ACCESSION NBR: 8510080455 DOC. DATE: 85/10/02 NOTARIZED: NO DOCKET #
 FACIL: 50-261 H.B. Robinson Plant, Unit 2, Carolina Power & Light Co. 05000261
 AUTH. NAME: AUTHOR AFFILIATION
 ZIMMERMAN, S.R. Carolina Power & Light Co.
 RECIP. NAME: RECIPIENT AFFILIATION
 VERGA, S.A. Operating Reactors Branch 1

SUBJECT: Provides addl info re valves in ESF sys which failed to satisfy NRC review guidance for Generic Item B-24, per 831205 ltr. No mods necessary. Related drawings, including one oversize drawing, encl.

H. B. ROBINSON STEAM ELECTRIC PLANT, UNIT NO. 2
DOCKET NO. 50-261/LICENSE NO. DPR-23
COMPLETION OF GENERIC ITEM B-24 RESPONSE
CONTAINMENT PURGING/VENTING DURING NORMAL OPERATION

EXCESS LETDOWN HX.
OUTLET ISOL. VA. 739

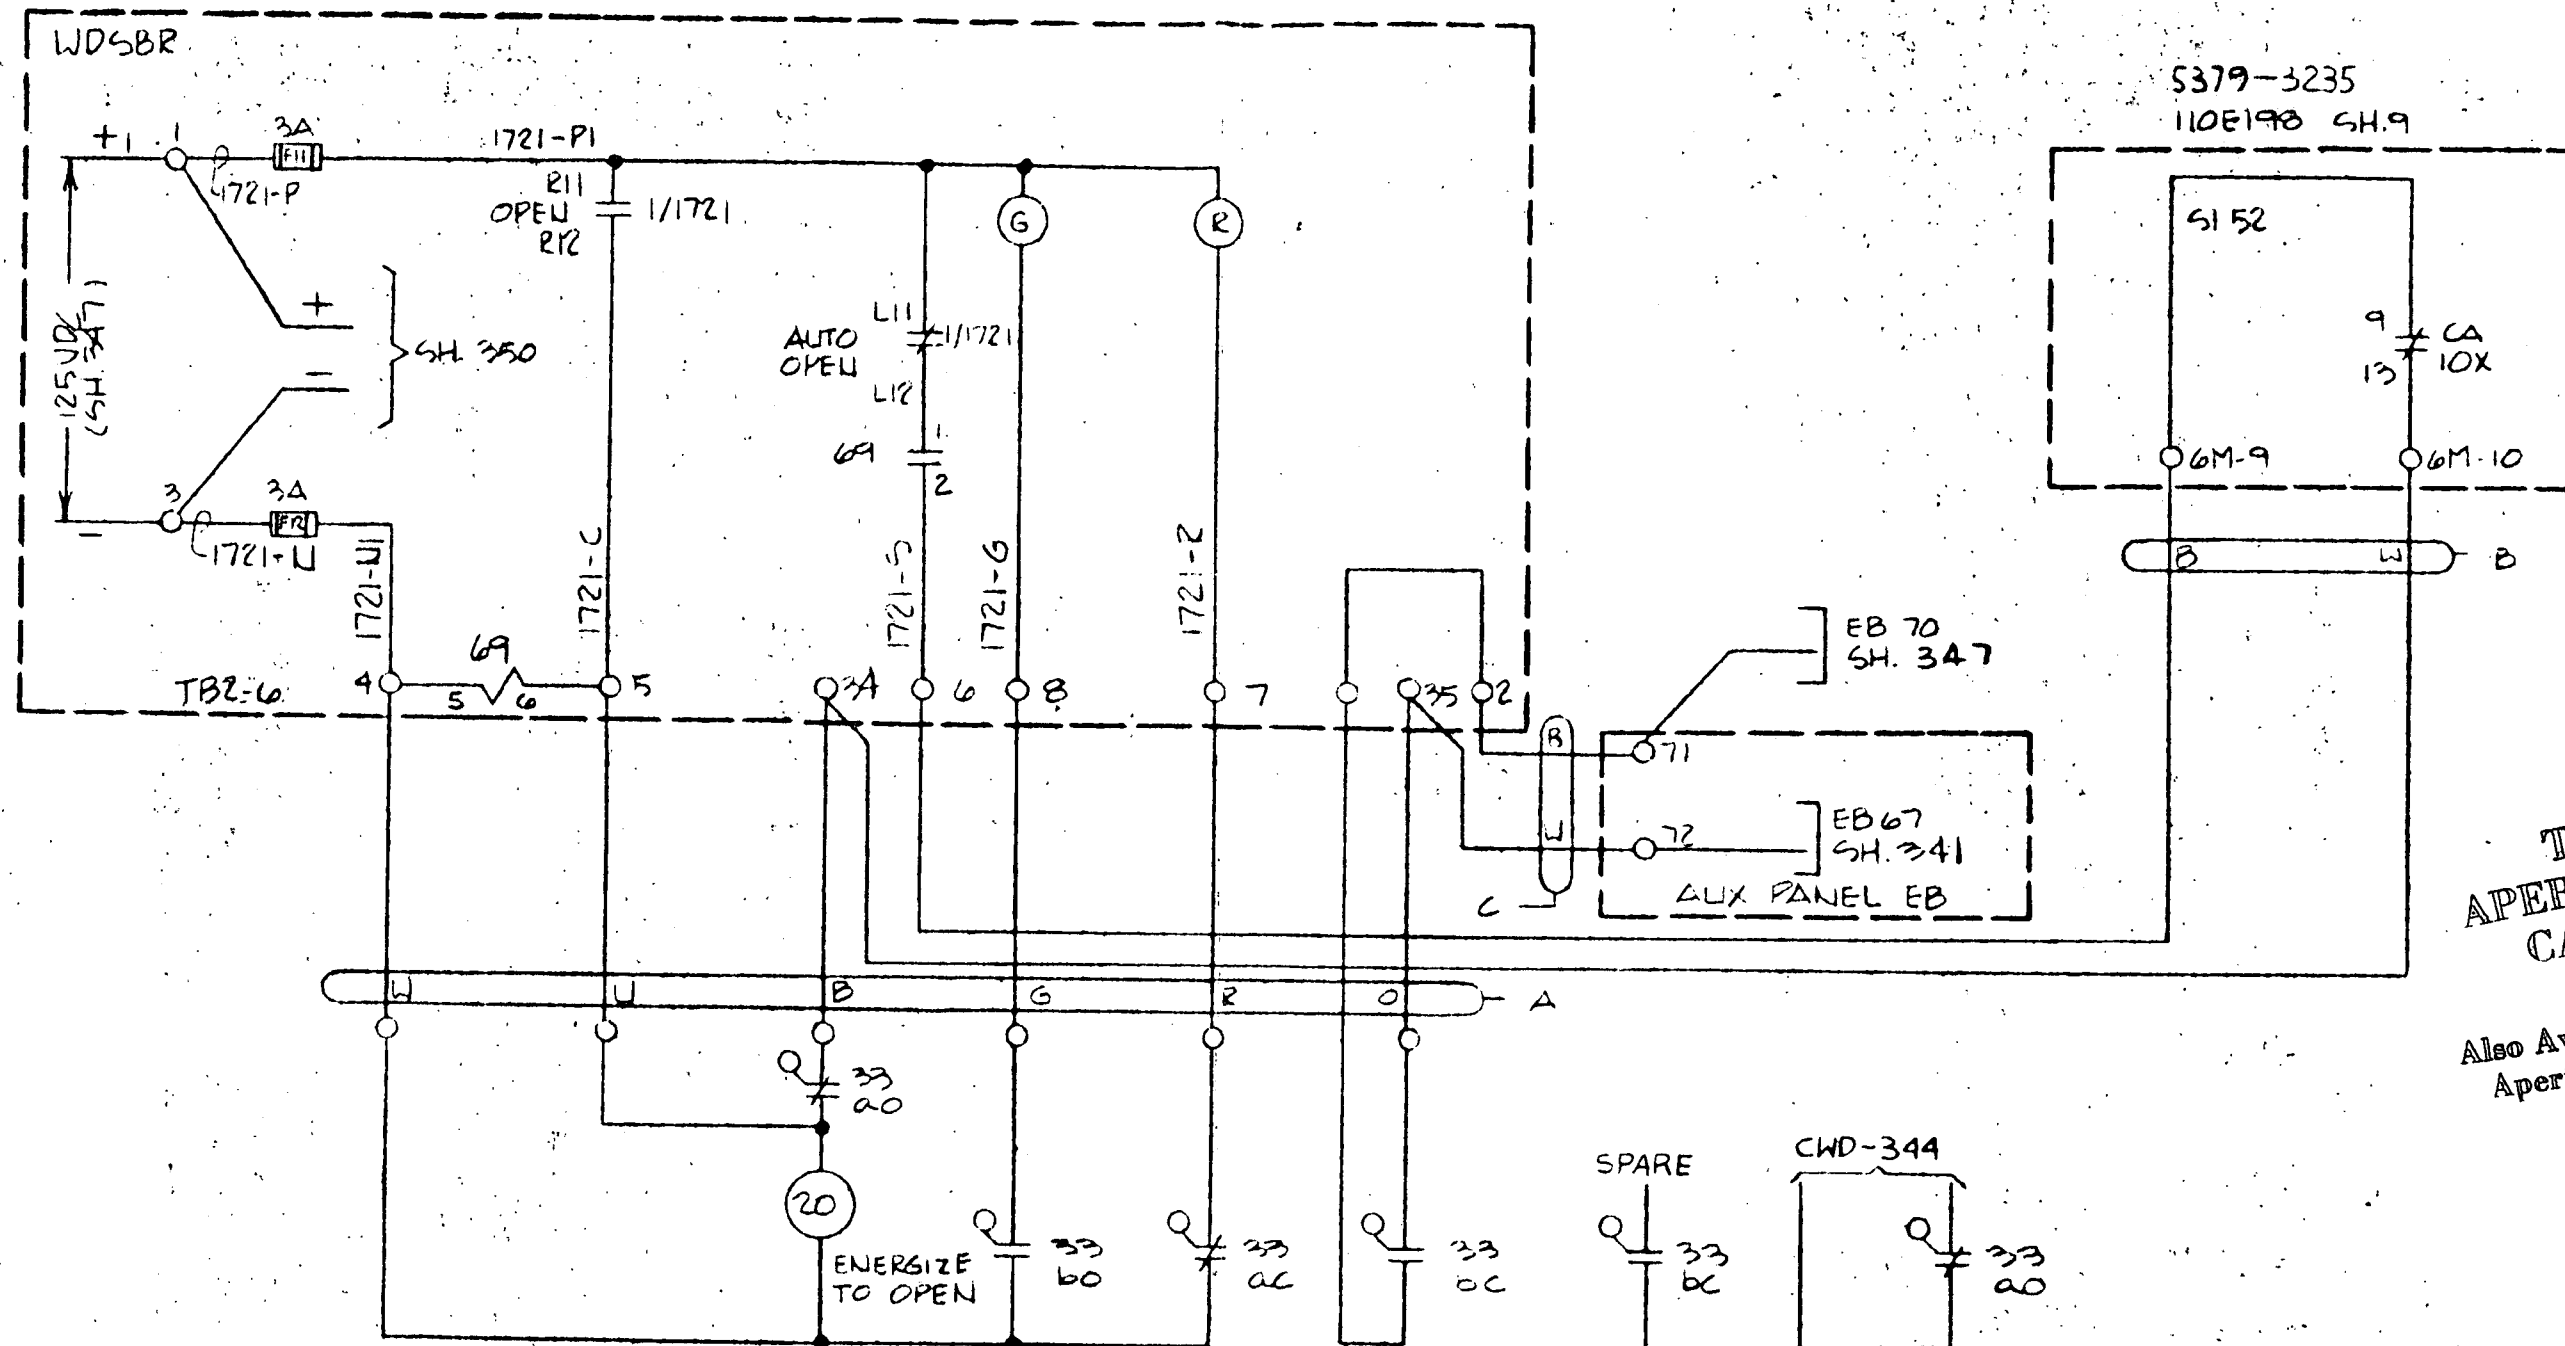
The TER discussion of ESF control circuits indicated that equipment level bypasses are provided for at least three valves (V-739, Component Cooling Water outlet isolation valve for the Excess Letdown Heat Exchanger, and V-1786 and V-1721, Waste Disposal System containment isolation valves) which, if activated following one safety activation signal, will block a second safety activation signal (or an initiating signal if actuated prior to receipt of the signal) thus, preventing the equipment from performing its protective action.

The TER also noted at least one valve (V-739) which will change position upon the reset of an ESF actuation signal. This valve, as well as other valves which activate on an ESF signal, were modified to satisfy the Westinghouse Technical Bulletin NSD-TB-77-13 concern regarding safety-related, stem-mounted limit switches. Such a valve will now close when an ESF actuation signal is received, and will remain closed until the isolation signal is reset, and the operator manually reopens the valve. Therefore, the valve will not change position upon reset of an ESF actuation signal.

Carolina Power & Light Company believes the ESF systems at HBR2 meet the intent of the review guidance, and no modifications are necessary.
